Subject: More problems with the Permit Packages

Above, SHEB 157 and 158. They are labeled with the same non-functional scale.

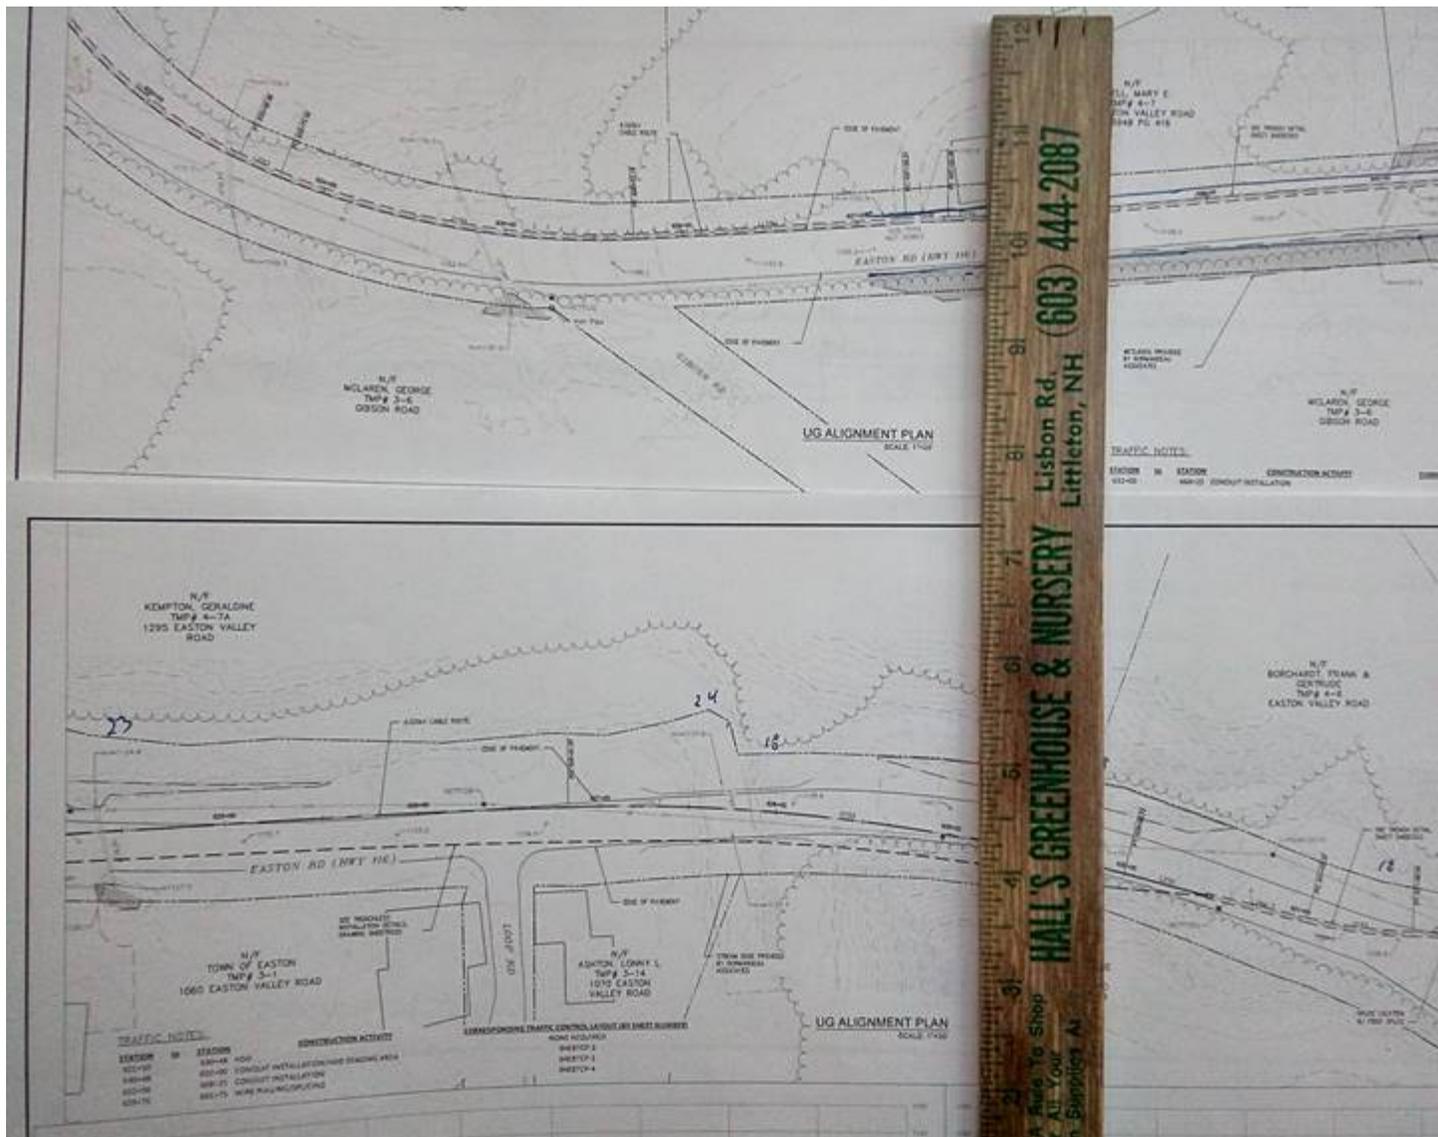
In addition, the width of the road width claimed differs between the pages though the scale is the same. One is 1" and the other is 18/16"

Are your engineers not driven mad by the use of private property markers for defining road width, which make the supposed road width change incrementally all over the maps, with occasional leaps (see above 18/16-24/16), not to mention the shifting of the center of the claimed easement to compensate for markers too close to the road?
